Agenda Item 4
744 Northmoor Road
Alterations and Second Story Addition

Consideration of a request for approval of a second story addition for living space over an attached garage.

Agenda Item 5
821 Northmoor Road
Continued - Revisions to Previously Approved Plans
Building Scale Variance and Height Variance

Continued consideration of a request for a recommendation in support of mid-project revisions to previously approved plans for additions and alterations to the residence at 821 Northmoor Road. A building scale variance is requested.

PROPOSED FRONT AND REAR ELEVATIONS
(NORTH AND SOUTH)

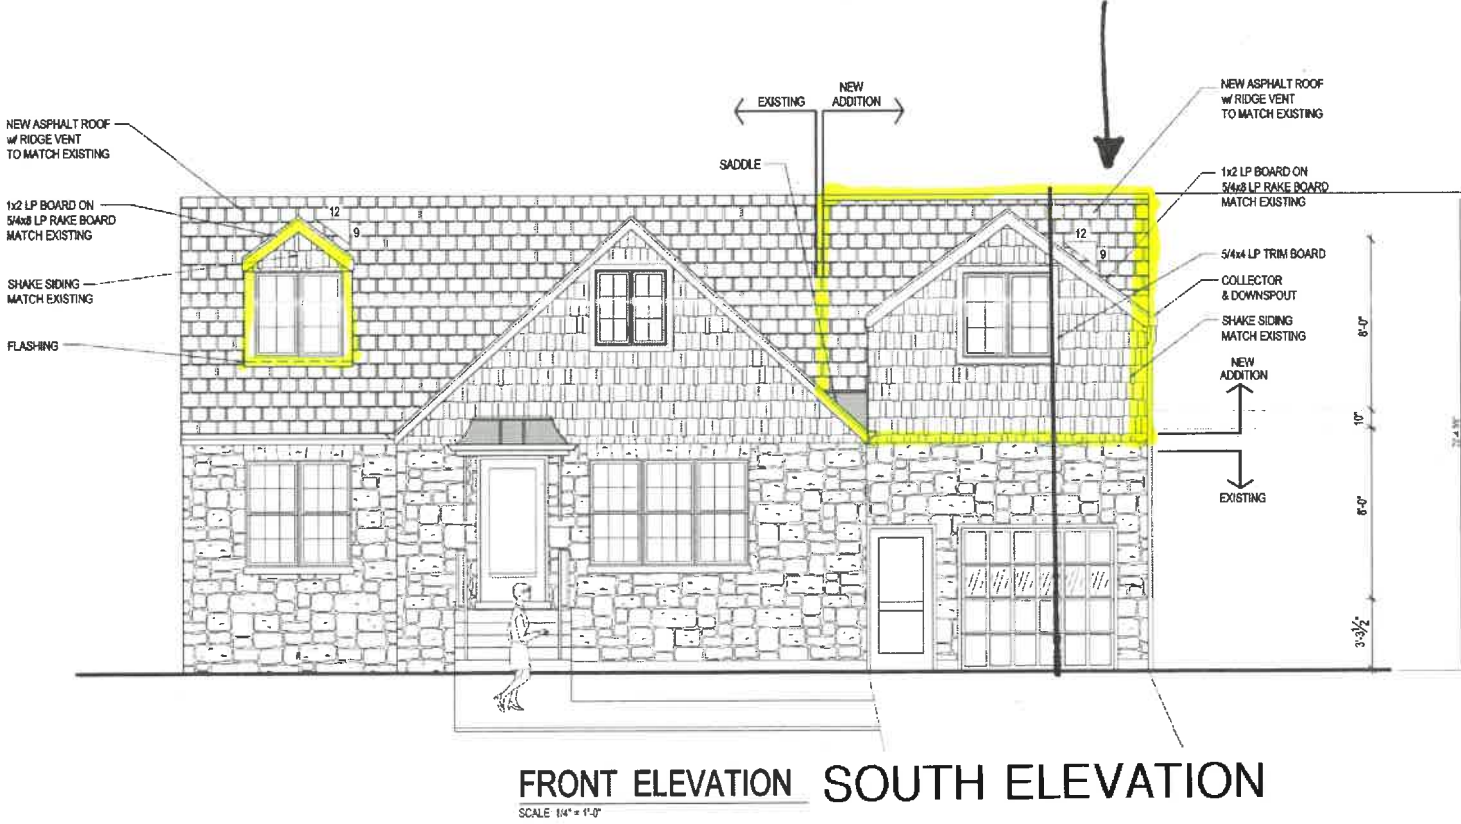
The proposed addition and alterations modify the overall appearance and symmetry of the home. On the south (front) elevation, the false gabled façade above the garage is proposed to be replaced by an addition with a real gable and a set of casement windows. A dormer is proposed on the opposite side to balance the elevation. The roof pitches on the gables across the front elevation appear to be consistent.

A desire to utilize the existing foundational support while maximizing the interior space for the proposed bedroom addition presents challenges for the design. The second floor addition appears elongated vertically in comparison to the main mass of the house however, it is recessed back from the front plane of the house.

Staff Recommendation: Consider refining the design of the proposed dormer and gable to better fit the south elevation.

A gable and alterations are also proposed on the north (rear) elevation.

Staff Recommendation: Consider refining the size and arrangement of windows for consistency on the north elevation.

1. Prior to the submittal of plans for permit make the following refinements based on Board direction. The refinements shall be subject to staff approval.
 - a. Refine the design of the proposed dormer and gable to better fit the south elevations.
 - b. Refine the size and arraignment of windows on the north elevation for consistency.
2. All modifications to the plans including those detailed above and any others made in response to Board direction or as the result of final design development, shall be clearly called out on the plans submitted for permit. Staff is directed to review any changes, in consultation with the Chairman as appropriate, to determine whether the modifications are in conformance with the Board's direction and approval prior to the issuance of any permits.
3. Prior to the issuance of a building permit:

PROPOSED SIDE ELEVATIONS CROSS SECTION AND ROOF PLAN

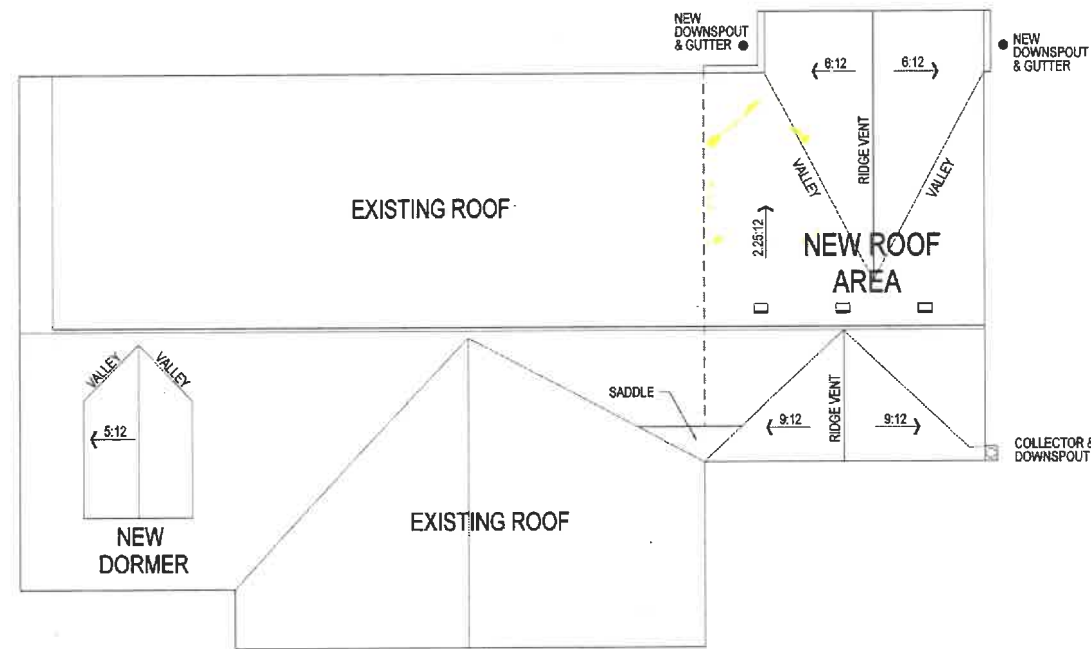
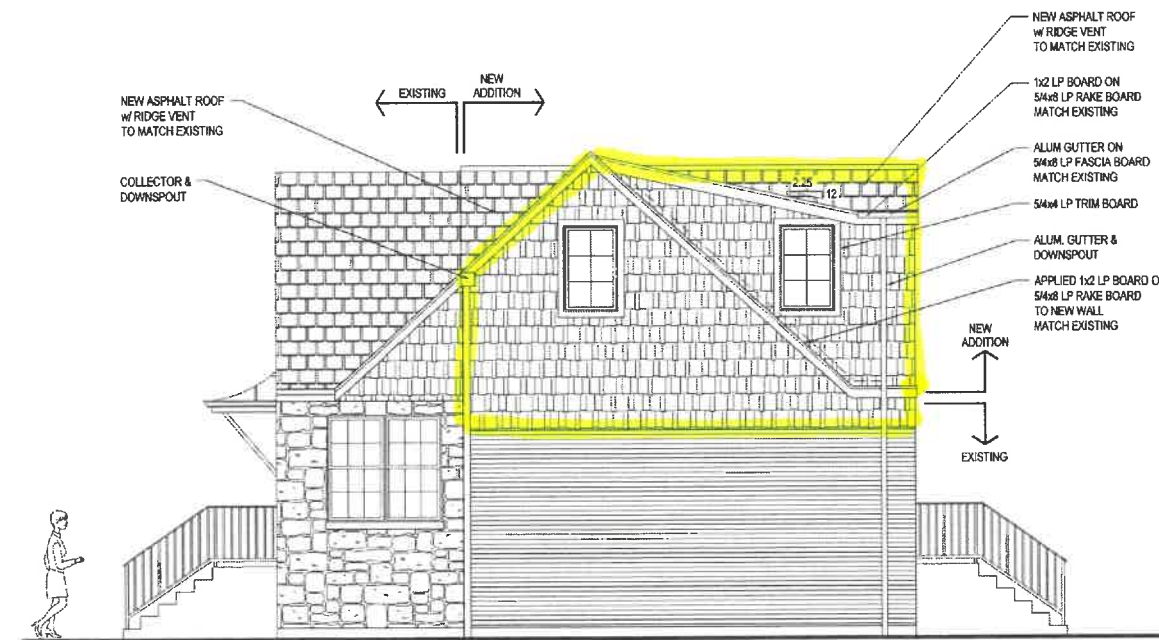
On the east elevation, the proposed addition adds two new casement windows above the existing garage. On the west elevation, the addition adds some massing to the rear of the home.

NORTH AND WEST ELEVATION

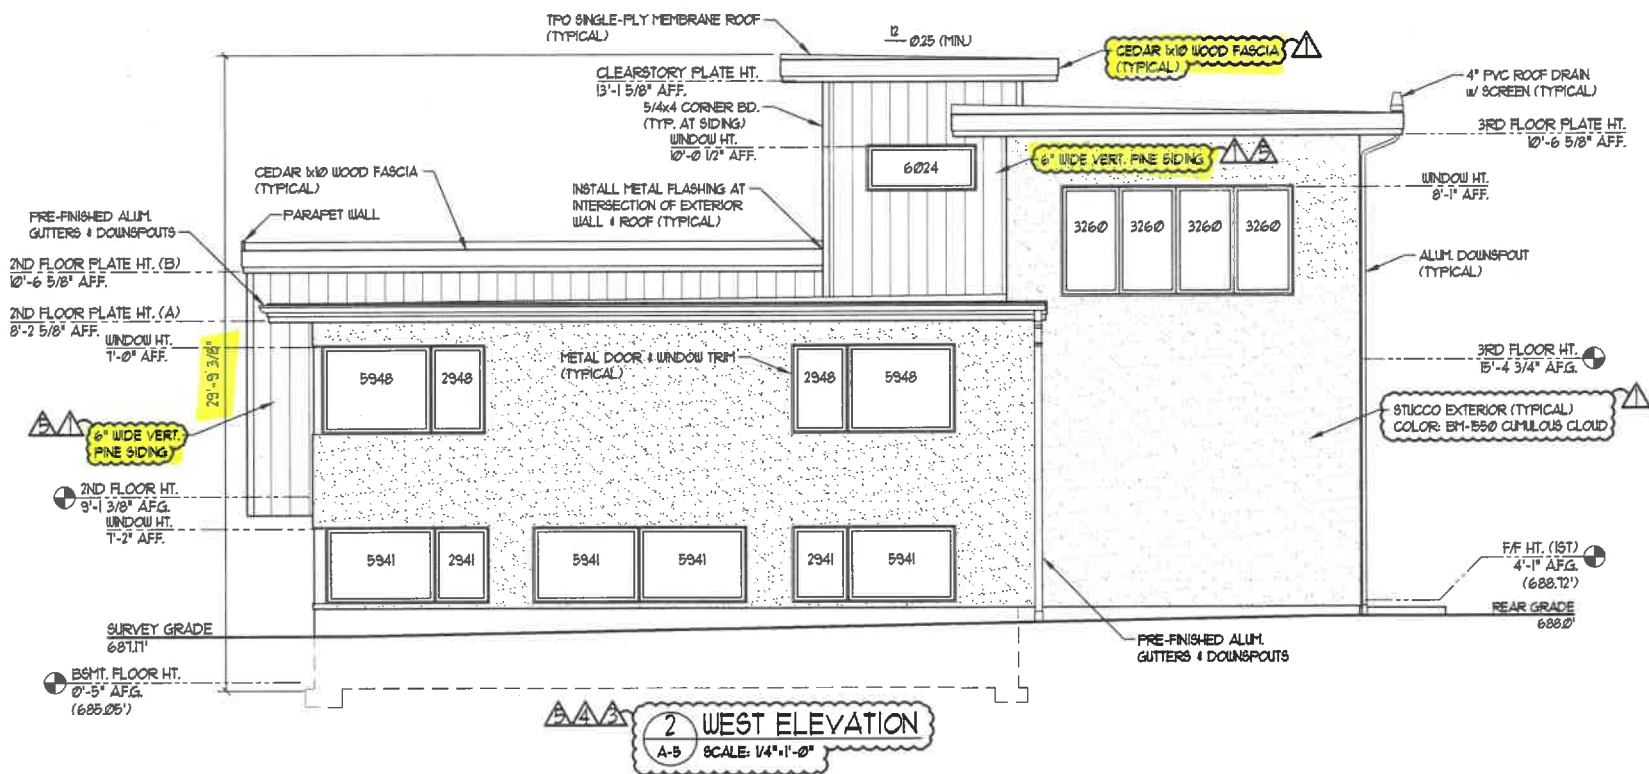
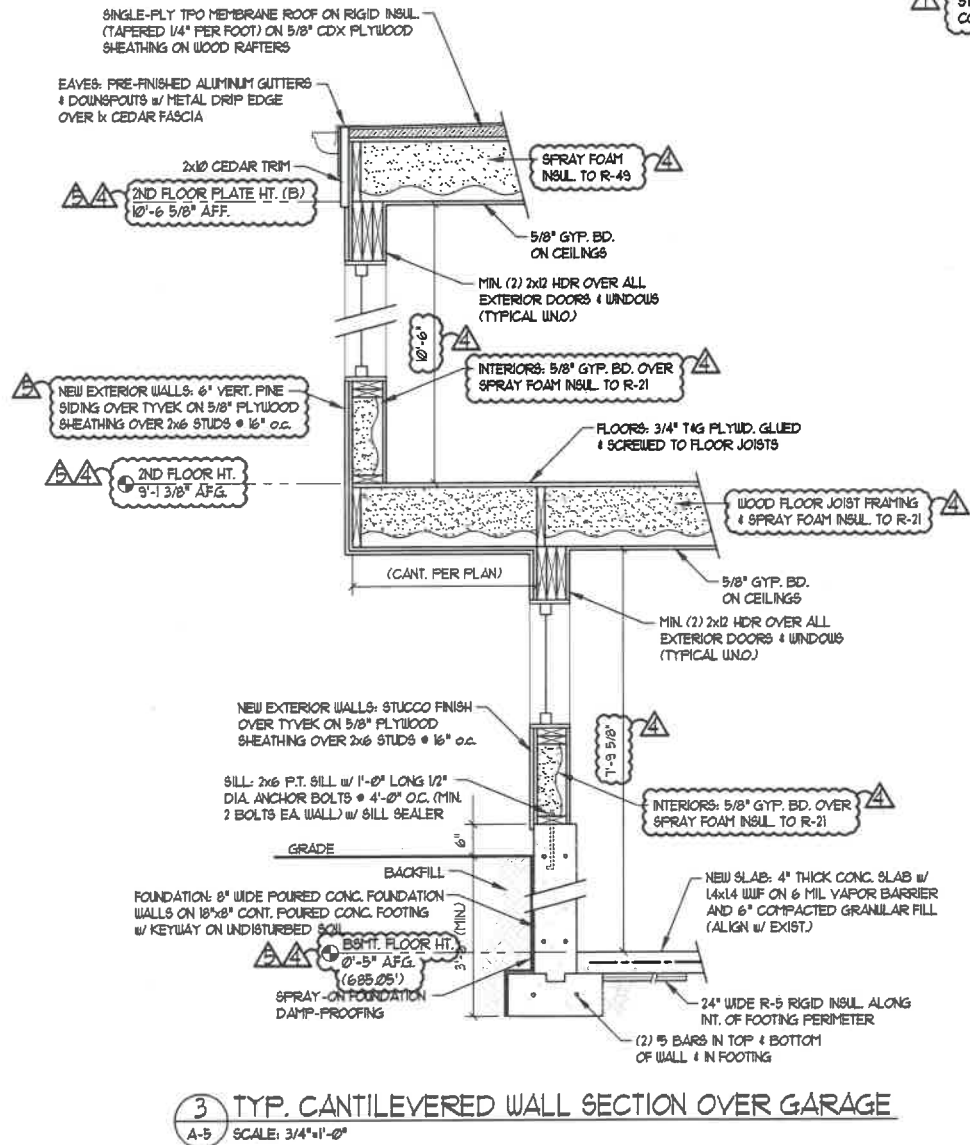
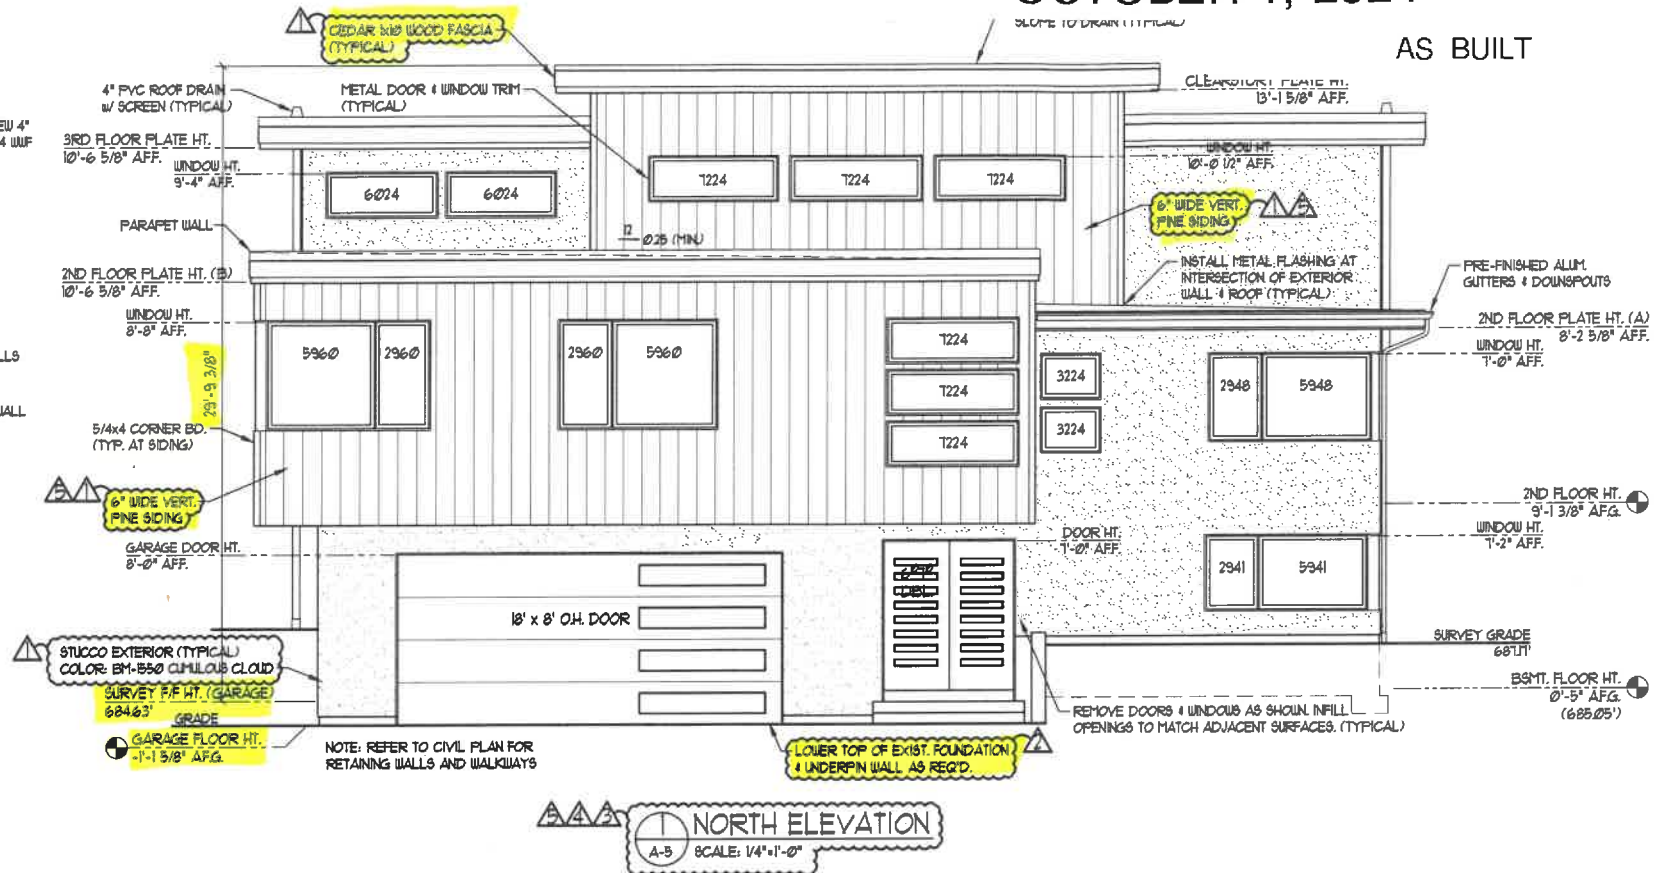
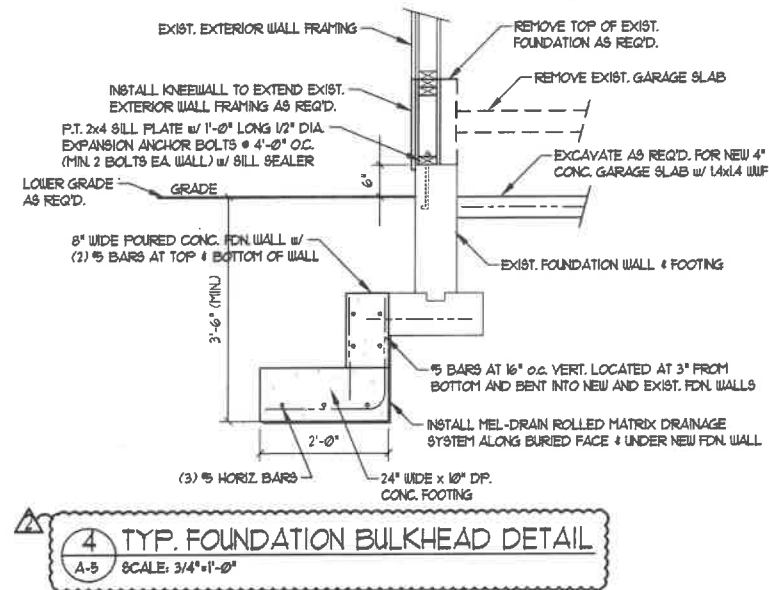
The petitioner has stated the intention not to exceed the allowable height of 30 feet as measured from the lowest point of existing grade adjacent to the residence. In the Statement of Intent, the petitioner states, “The Clearstory roof has been lowered”, however no dimension is provided to verify how much the unapproved element will be lowered.

Recommendation: Direct the petitioner to provide dimensioned plans both as built and as now proposed that clearly illustrate, with dimensions, all areas where

modifications to the as built condition will be made to adhere to the maximum allowable height.

LANDSCAPE PLAN

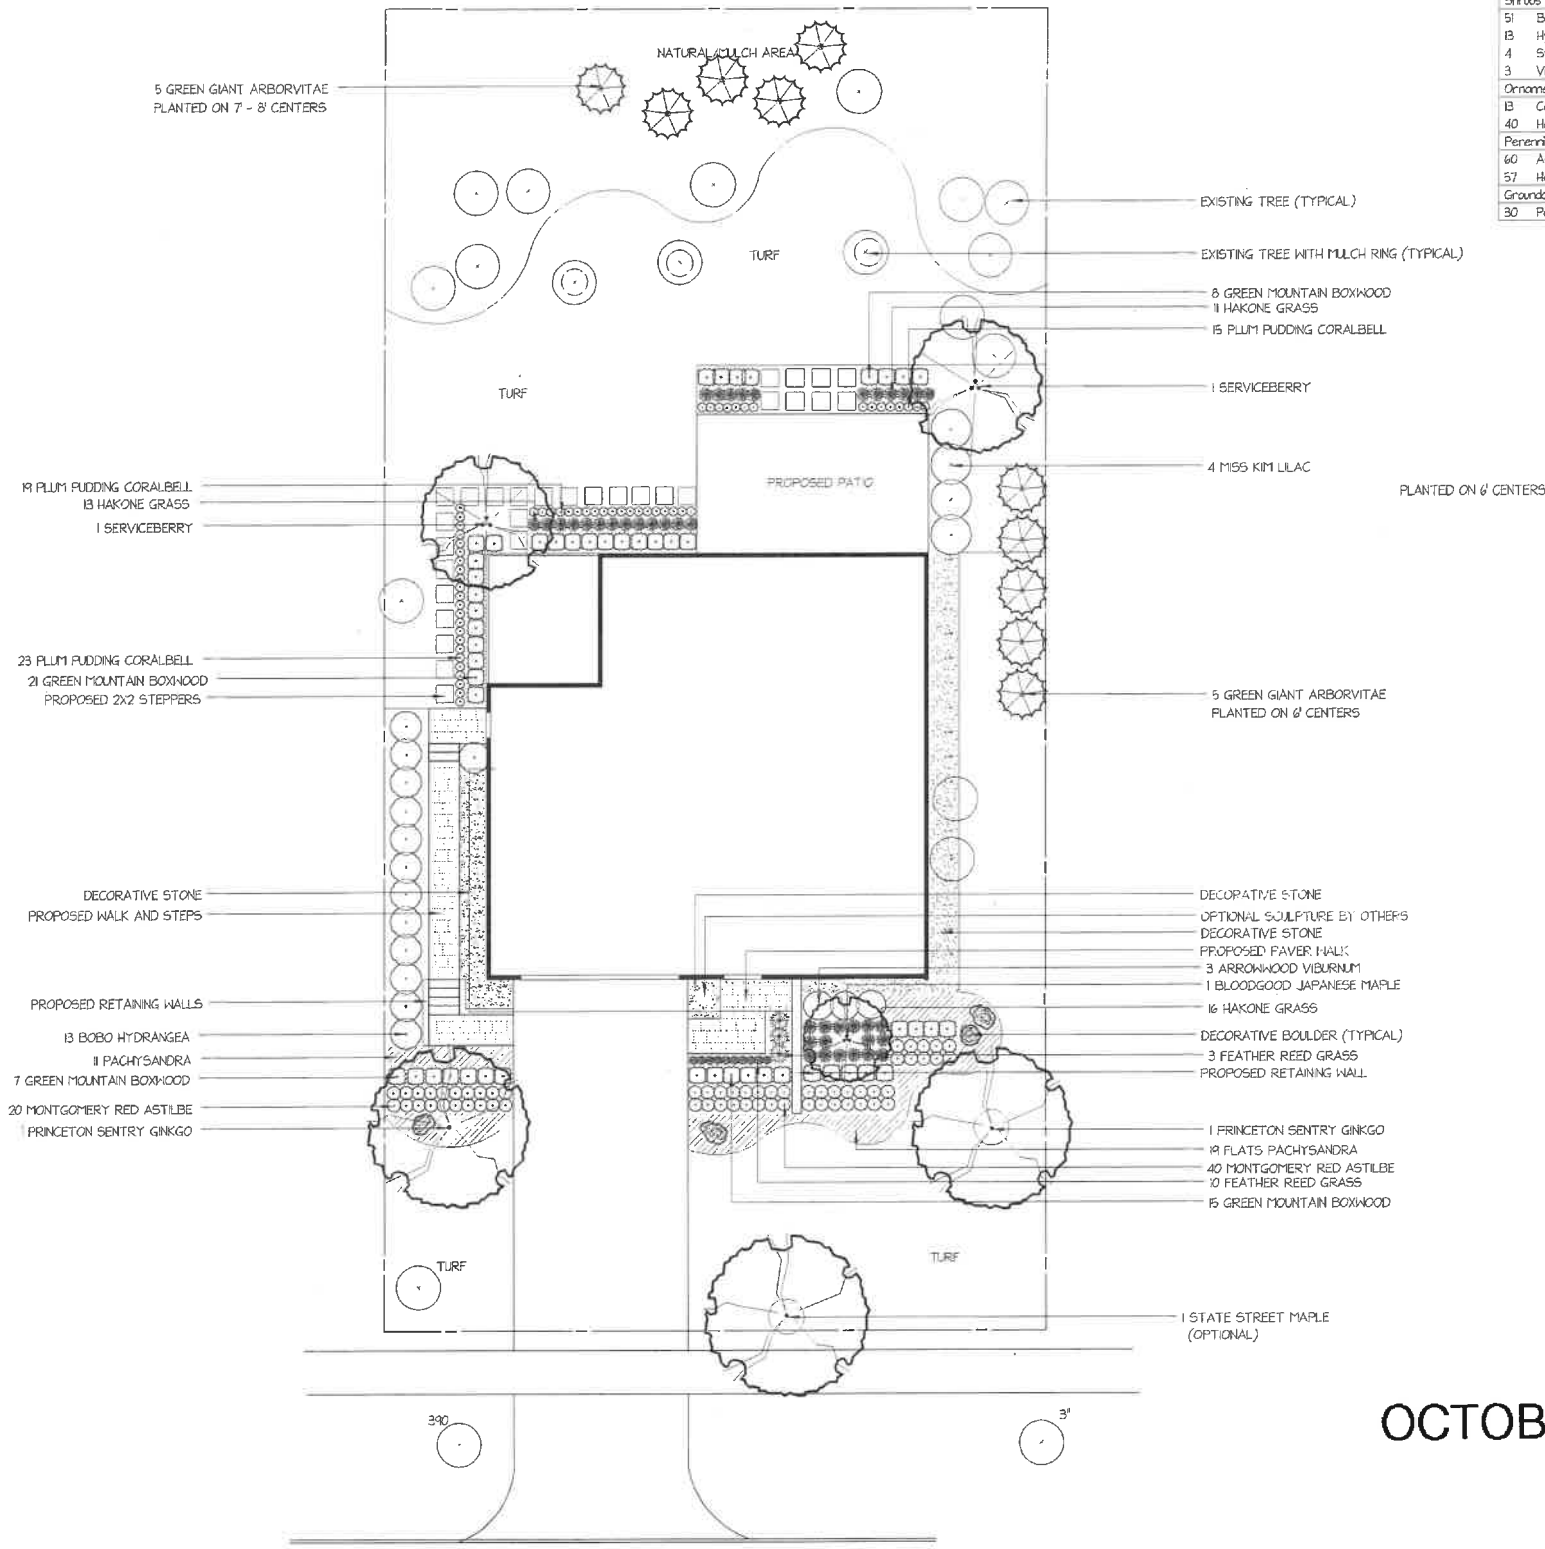
The landscape plan now includes 10 new arbor vitae bushes, 5 along the west property line and 5 along the south property line to provide additional privacy screening and to block light spillage concerns. The additional arbor vitae bushes proposed will help mitigate the privacy and light concerns from the windows in the master bedroom but can't fully hide the excessive size of the structure.

Recommendation: The Green Giant Arborvitae should be at least six feet in height at time of planting.
